CLARKSBURG LIBRARY

Capital Improvement Project No. 710500

Historic Preservation Commission Presentation

December 3, 2025

15. Enlarged Site Plan With Dimensions and Proposed Materials

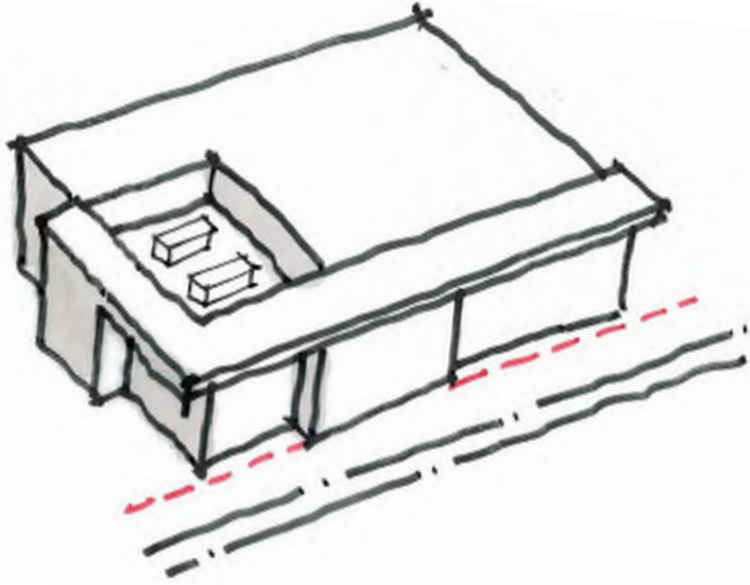
- **Annotated elevation drawings of all four sides of the proposed building;**
All renderings should be drawn to scale and eliminate opaque and translucent trees to allow better visibility of the proposed building and sitework;
- Information about **the construction** of Clarksridge Road including **grading information, road sections, and other detailed design information;**
- Details on the rehabilitation of the Day House including **updated and accurate landscape plans including dimensions and materials for the intermediary space.**

2 Suggested HPC Study

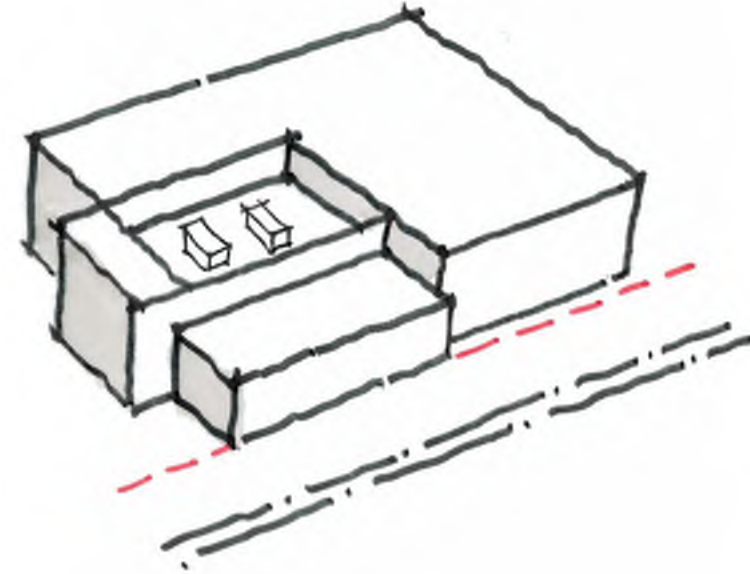
1. The acting chair recommended a study to **lower the building at the entrance**, closest to the Day House, and **stepping back the massing of the stacks area so its front wall aligns with the rear wall of the meeting rooms**. If this doesn't work with the design concept or function, it needs to be demonstrated to the HPC, not simply an internal exercise.
2. Study considering **additional horizontal elements** to reinforce the common pattern identified in the Vision.
